**IN THE DRAWINGS****Please amend the drawings as follows:**

Response to 4-15-03 Office Action  
Serial No. 10/003,589  
Page 13

Title: Vehicle Body with Integral Storage Area and Deck  
Serial No. 10/003,589/Inventor: Timothy Williams  
Attorney Docket No. 08152-00134

FIG. 1

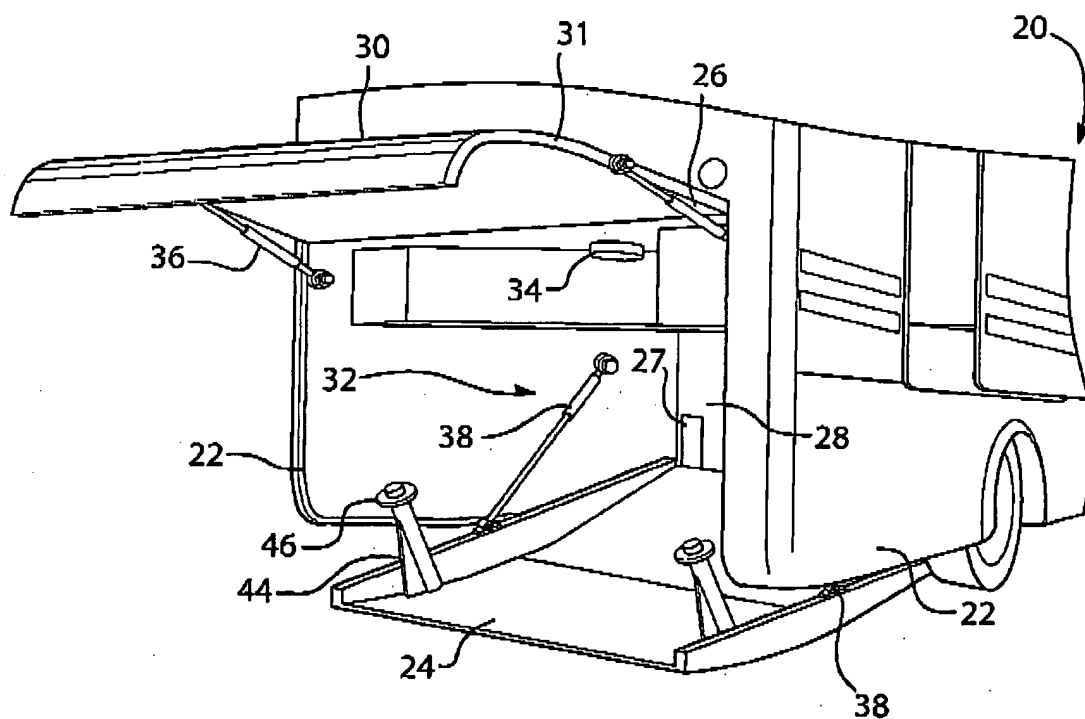
Replace sheets 1-3 of the original drawing sheets with the attached replacement drawing sheets 1-5. Figure 1 has been amended to include an access door 27, hydraulic lift cylinders 38, and hatch edge 31. Access door 27 was included in the original specification on page 7, line 14 and in claim 18. Therefore, the addition to the drawings of access door 27 does not add new matter to the application. Hydraulic lift cylinders 38 are shown in the original drawings as well as the specification and claims and therefore do not present new matter. The hatch edge 31 was disclosed in the specification on page 7, line 20 and has been added to Figure 1 with a reference number for further clarity and also does not add new matter.

FIG. 2

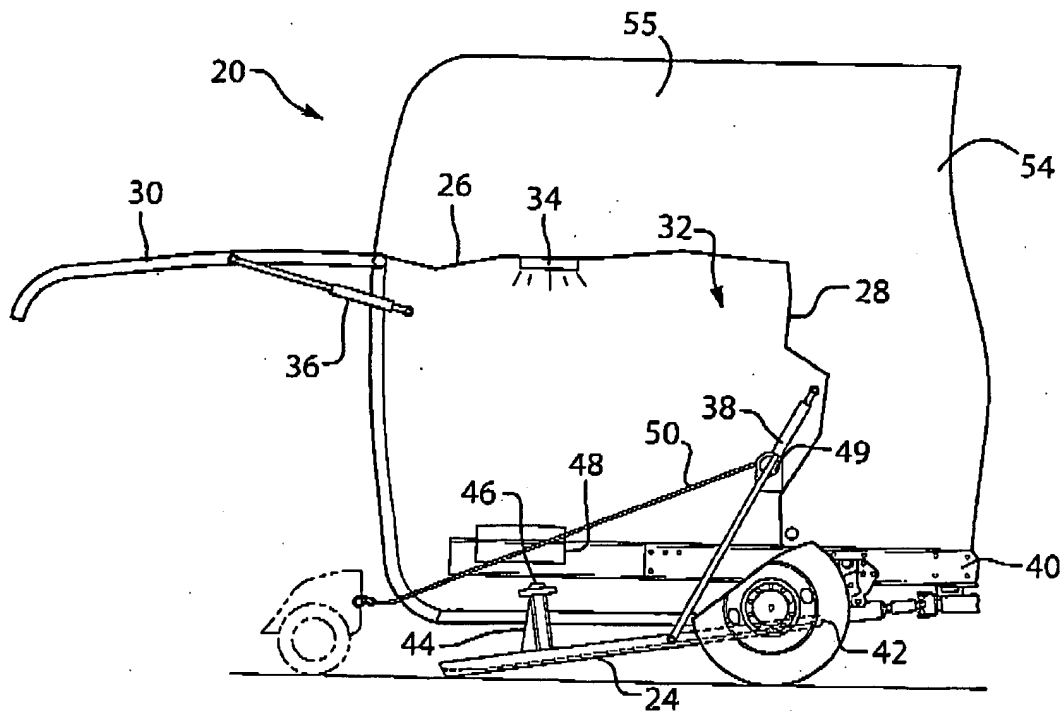
Figures 2 and 3 have been amended to include reference numbers 55 and 49 and to correctly identify reference number 50. Reference number 55 was added to the drawings to identify the additional storage space above the storage compartment as disclosed in original claims 15 and 18. Reference number 49 was added to indicate the winch device and reference number 50 has been amended to correctly identify the cable. Both the winch device and cable were disclosed in the original specification on page 8 lines 21-23 and therefore are not new matter.

Previous Figures 2, 3 and 5 contained a straight line indicating a view into vehicle 20. This straight line has been replaced with a wavy line to better indicate a cut away view into the vehicle 20 and has been made for clarity purposes.

FIG. 4

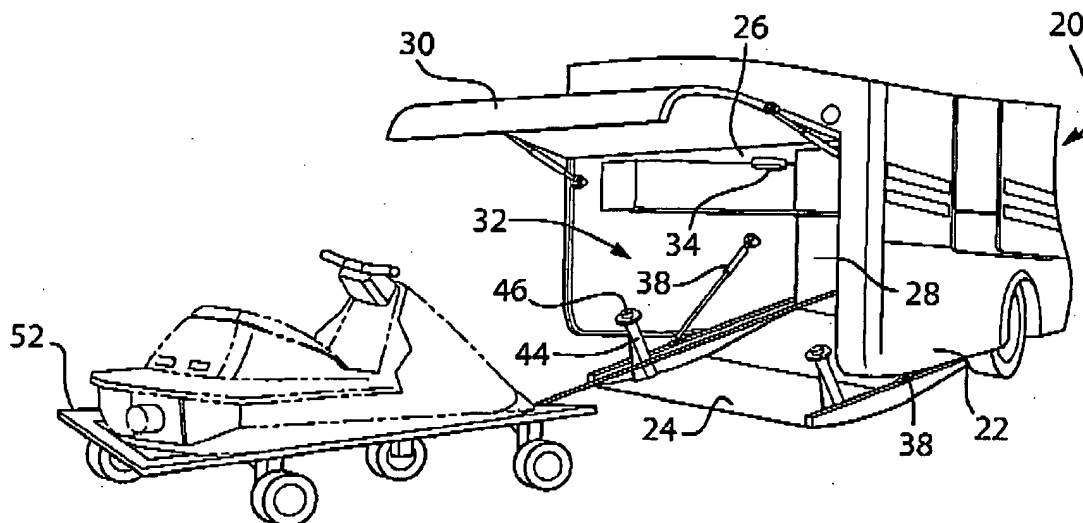
Figure 4 has been amended to add hydraulic lift cylinder 38. Hydraulic lift cylinder 38 was disclosed in the original specification and drawings and has been added to Figure 4 for clarification.

FIG. 6

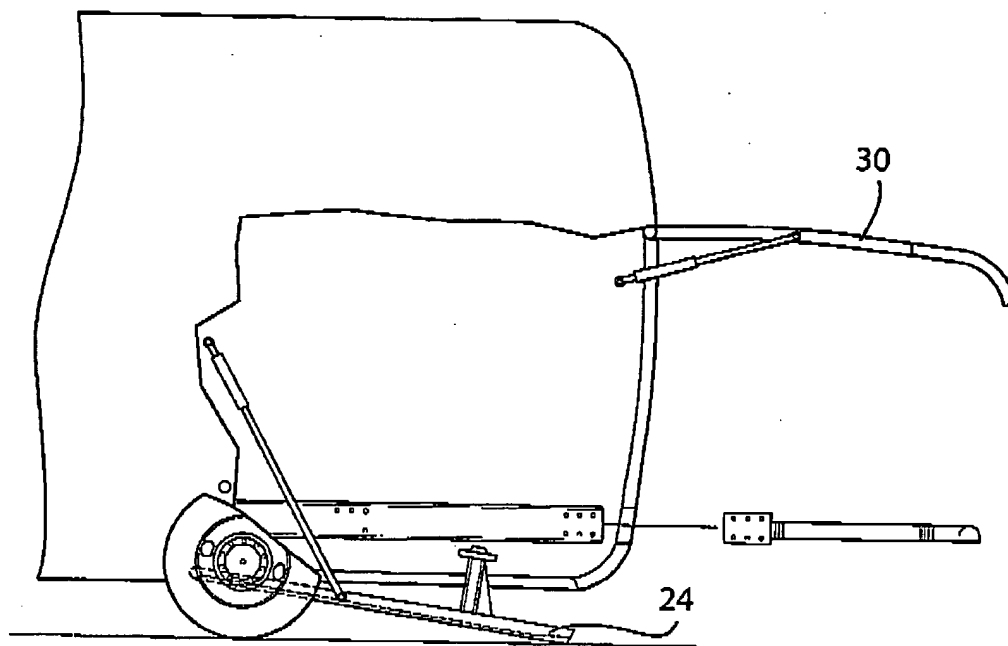
New drawing sheet 4 contains new Figures 6 and 7. Figure 6 has been added to show the hatch located in the front of the vehicle as disclosed in the original specification on page 7, lines 2-5 and original claim 17. Figure 7 has been added to show a second hatch located in an adjacent body panel as disclosed in the original specification on page 7, lines 5-7 and original claim 11. Figures 6 and 7 do not present new matter.
